Addendum #1

Stevens Farm Project – Heavy Use Area and Manure Storage

February 21, 2025

Date: 2025-01-31
Project No.: 13655-002
Sheet No.: G-002

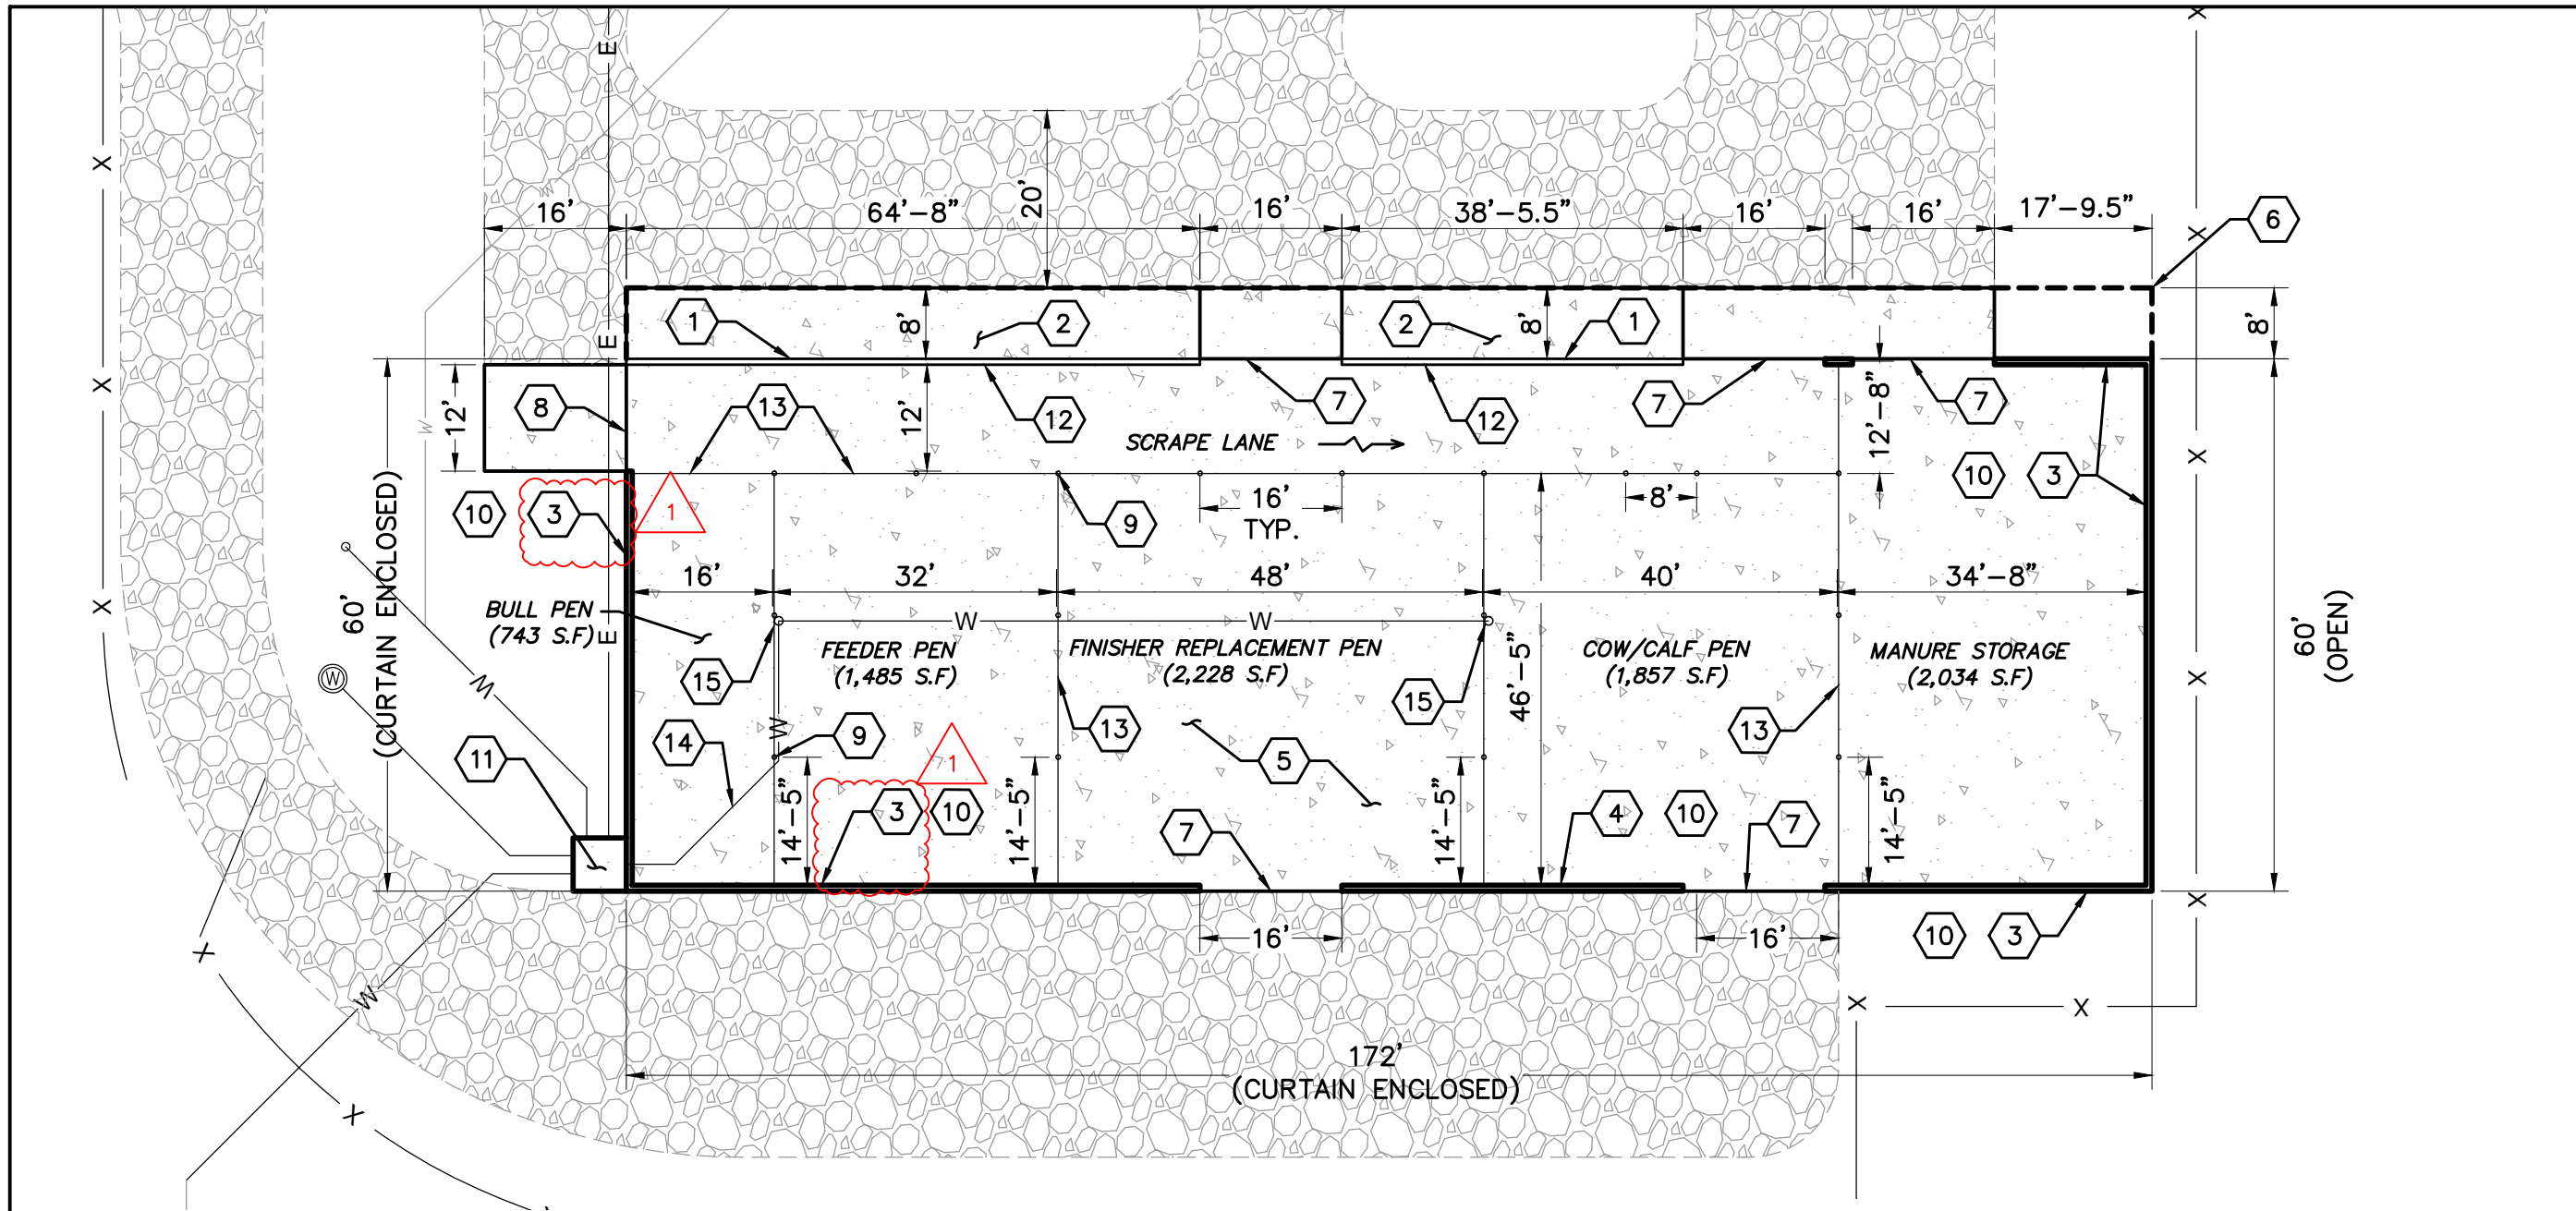
- Earthfill Note #4 was modified to call out an “on-site” inspector instead of the original “NRCS inspector” language. NRCS does not have any involvement with this project. All earthfill will be approved by the inspector on-site.

Date: 2025-01-31
 Project No.: 13655-002
 Sheet No.: **C-506**

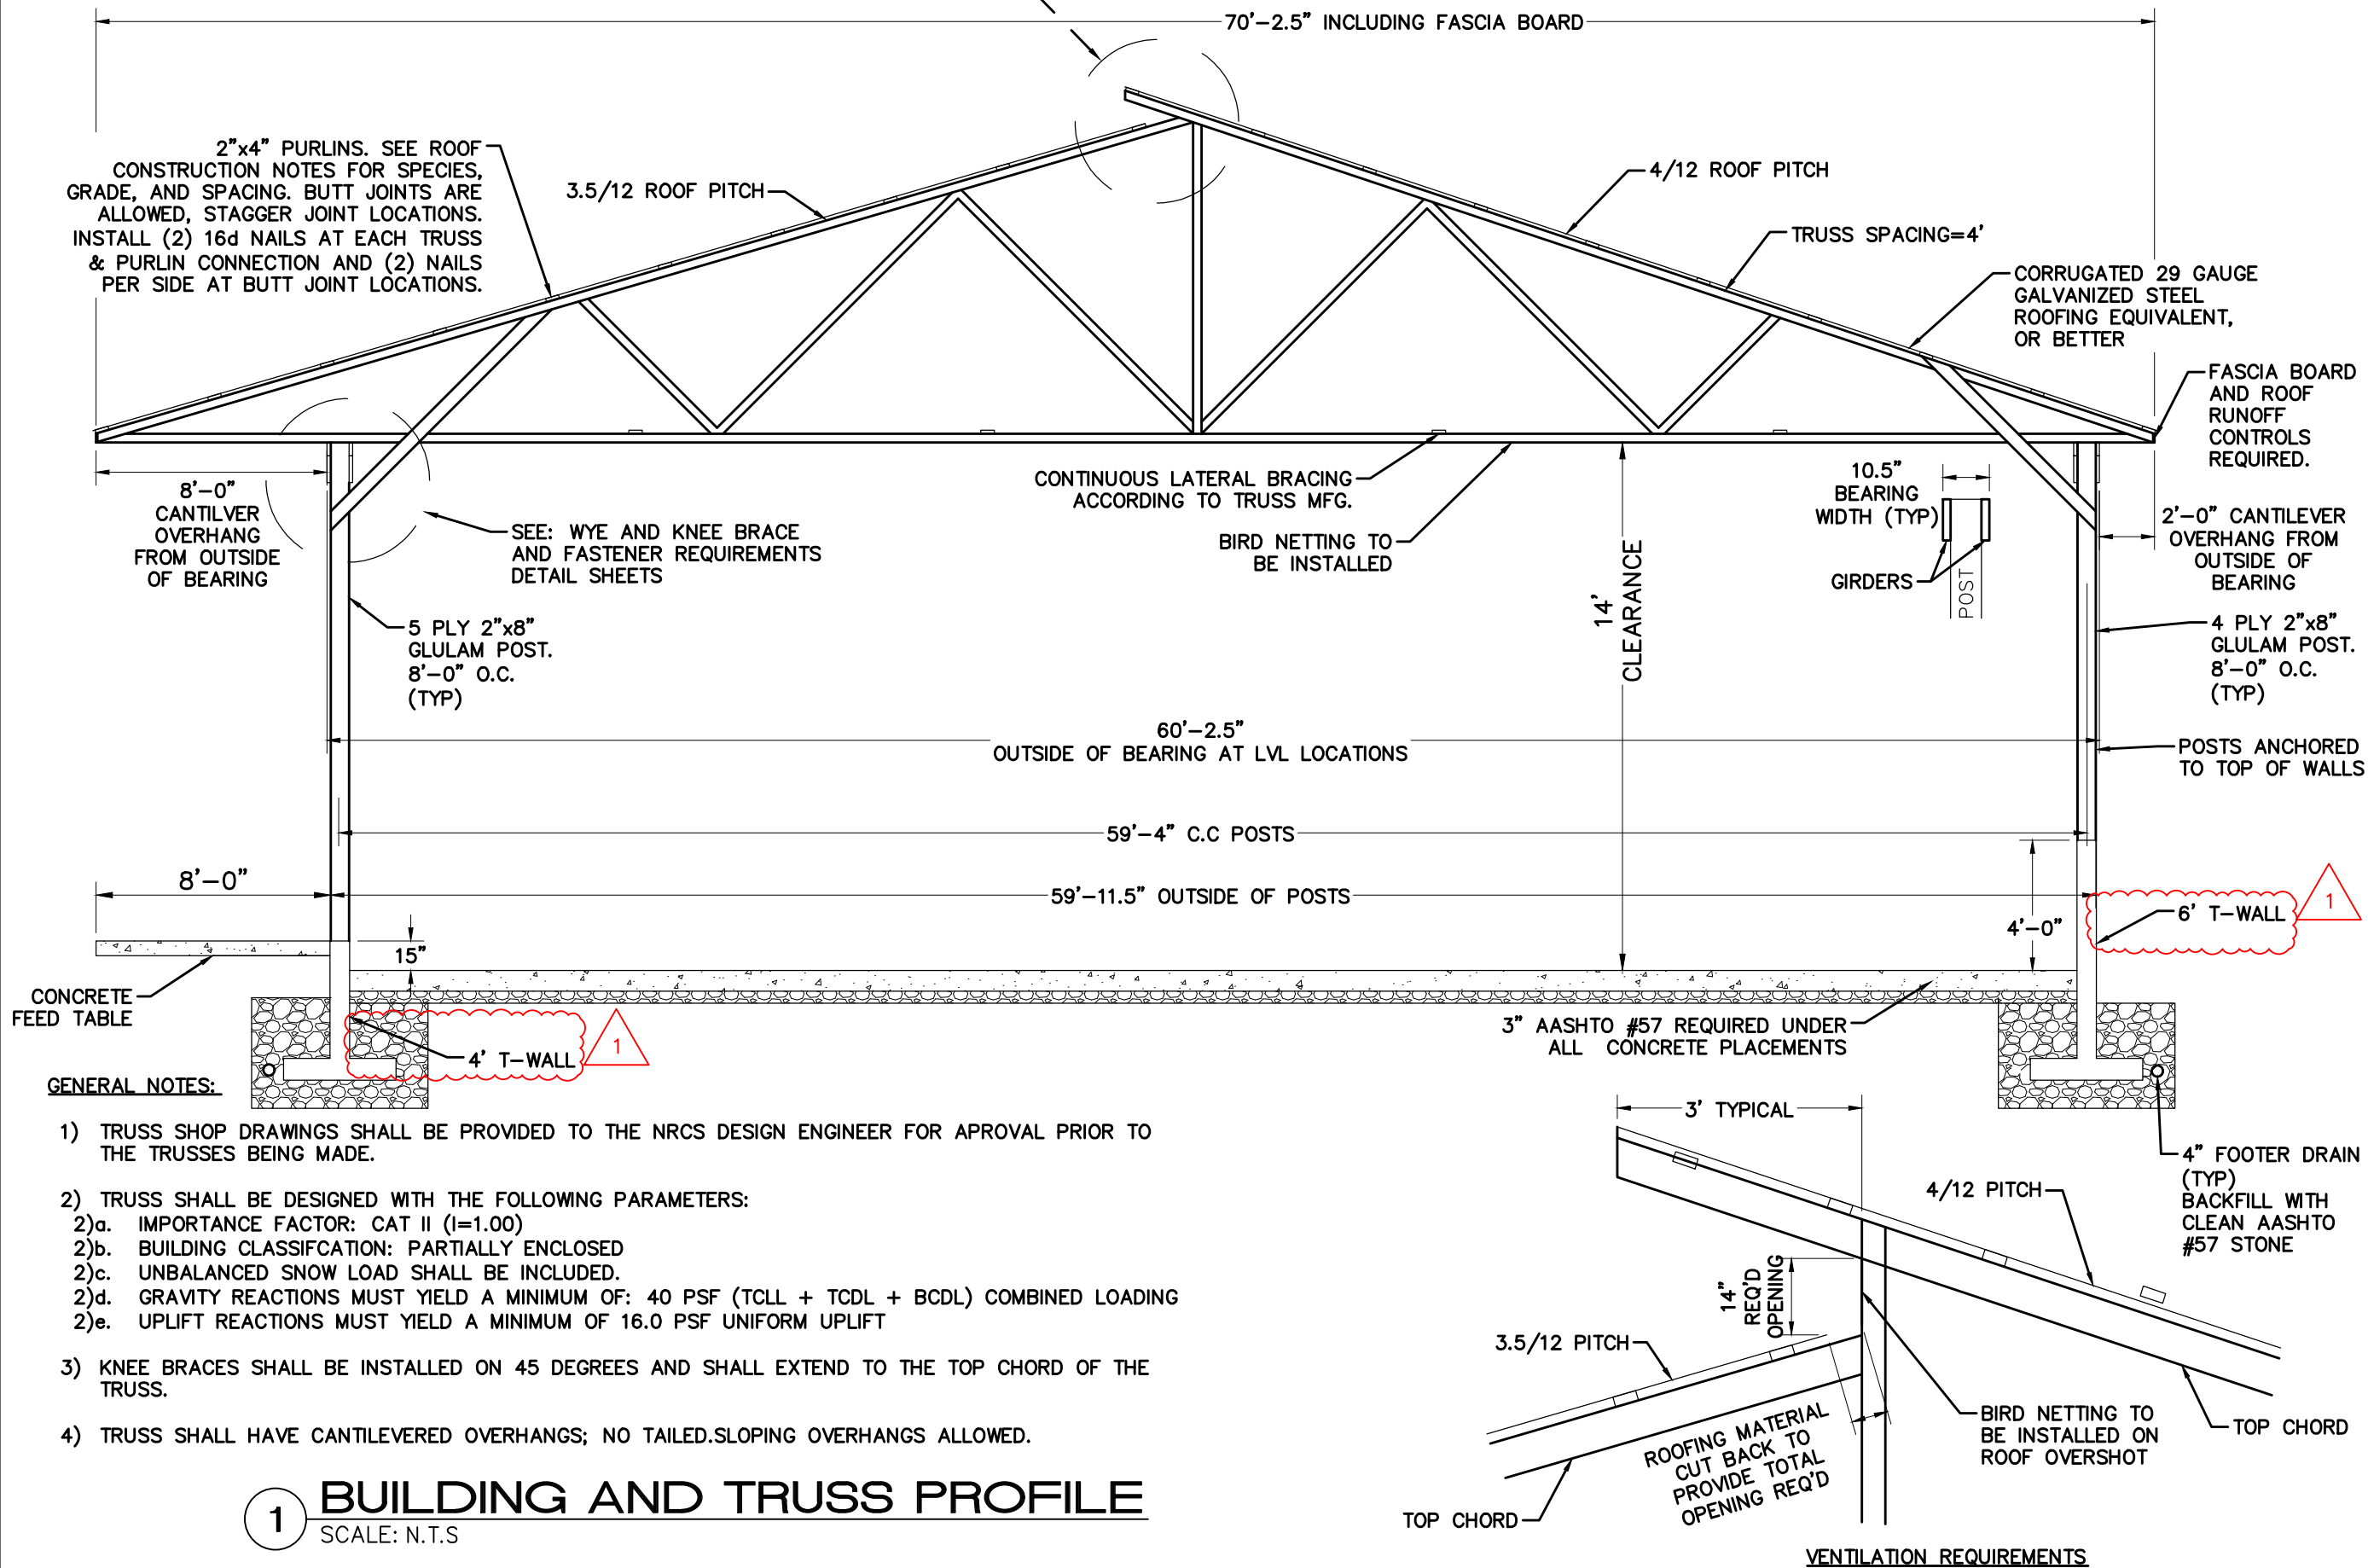
- For further clarification, the wall along the feed table (plan left) was labeled as “4’ T-Wall.”
- For further clarification, the opposing wall (plan right) was labeled as “6’ T-Wall.”

1 4' T-WALL WITHOUT SURCHARGE
 SCALE: N.T.S.

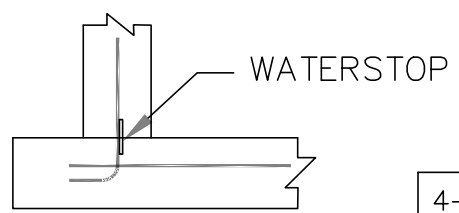
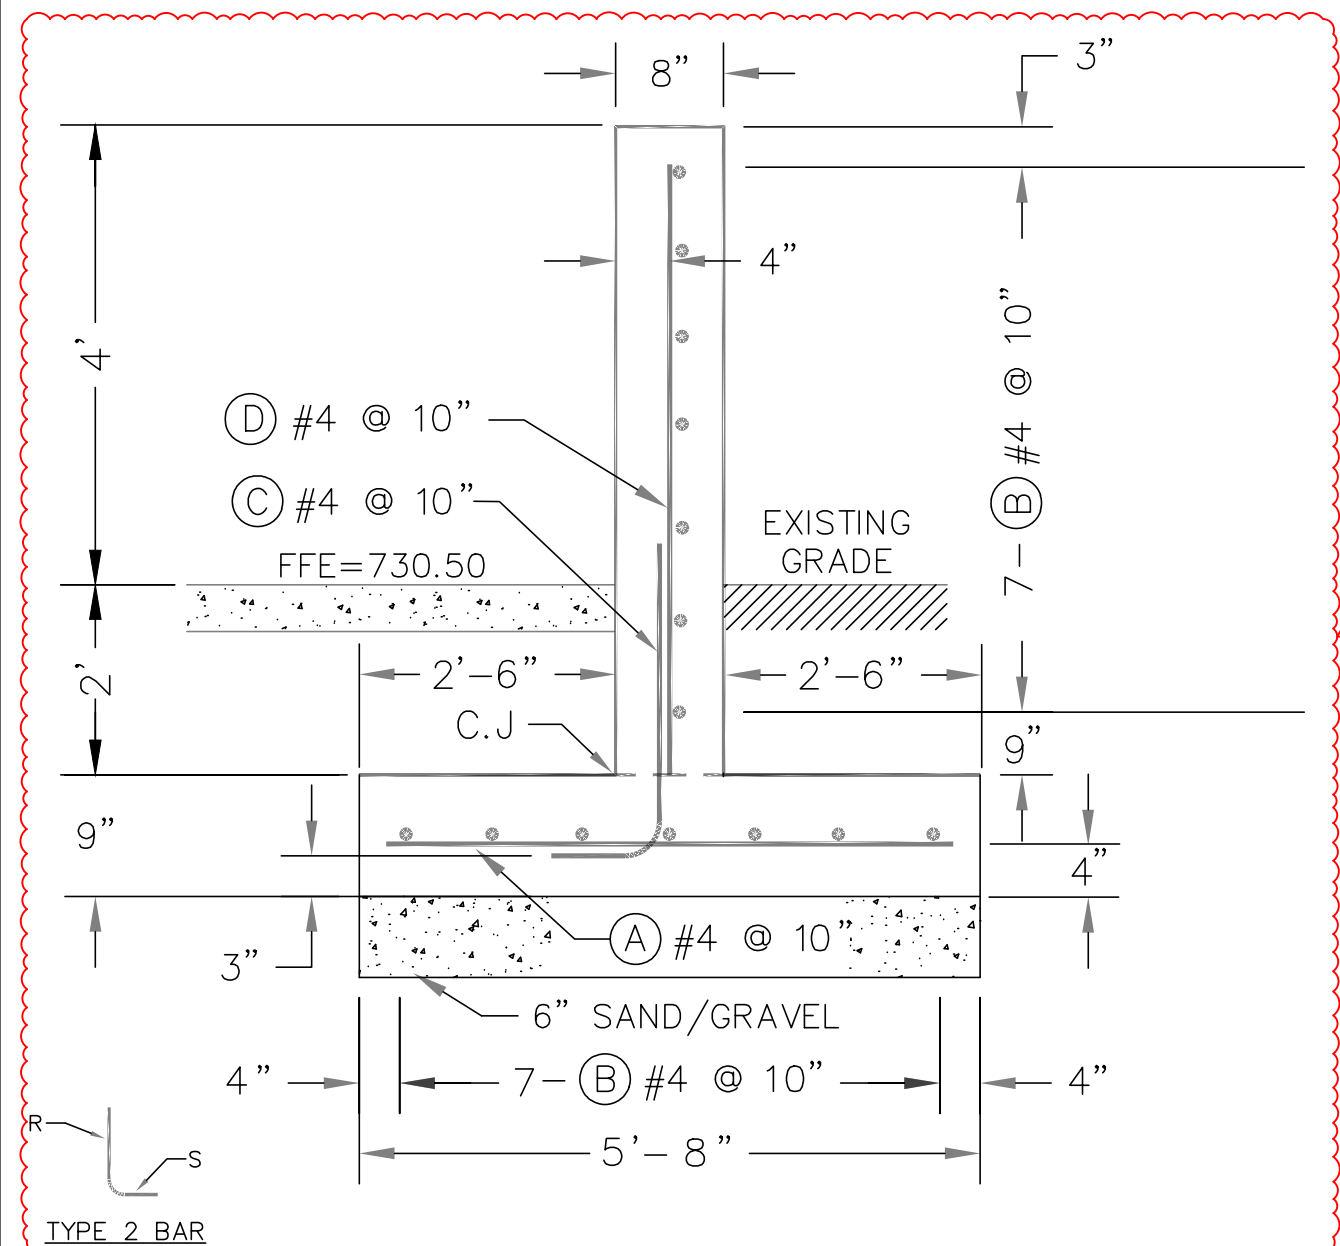
- This sheet is removed from the plan set as a 4’ T-wall is not required in locations outside of the feed table. See existing Detail 1/C-510 for 4’ T-wall at feed table.

1 PARTIALLY BURIED 6' T-WALL WITHOUT SURCHARGE 1
 SCALE: N.T.S

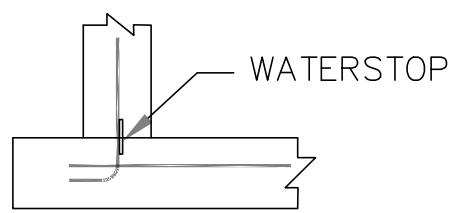
- For further clarification, the detail sheet title has been enhanced to address confusion regarding wall heights, and is now shown as: "Partially Buried 6' T-wall Without Surcharge."
- The detail section view has been edited to reflect the relationship between the top of wall, finished floor elevation, and top of footer elevations. Detail now clarifies that there is a 6' total wall height (4' above grade and 2' buried footer depth).
